Rezoning Transportation Analysis

Petition Number: 2019-094

General Location Identifier: 08307301

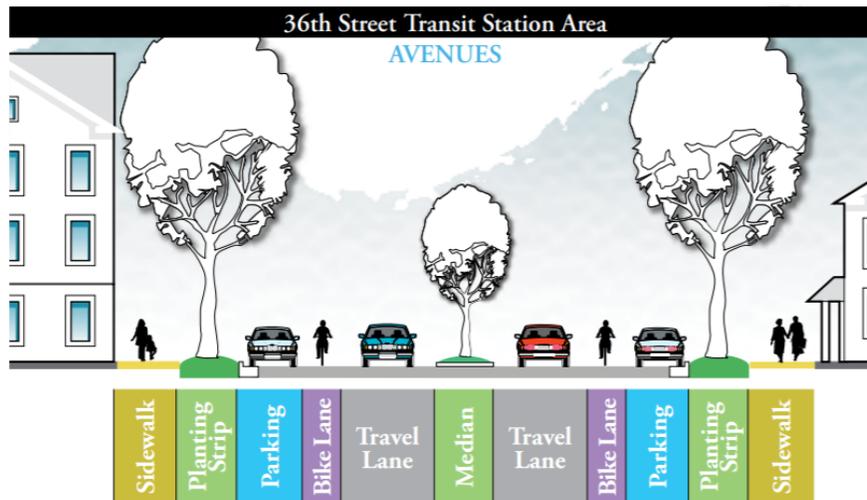
This site is located along a minor thoroughfare. CDOT is requesting the petitioner to update the site plan to show an 8' Planting strip followed by an 8' sidewalk as shown in the "Blue Line Extension Transit Area Plan" and required by the chapter 9 zoning ordinance.

Technical Correction: Site plan shows 8' Sidewalk followed by 8' Planting strip. Street scape should be in accordance with area plan which has 8' planting strip behind curb followed by 8' sidewalk.
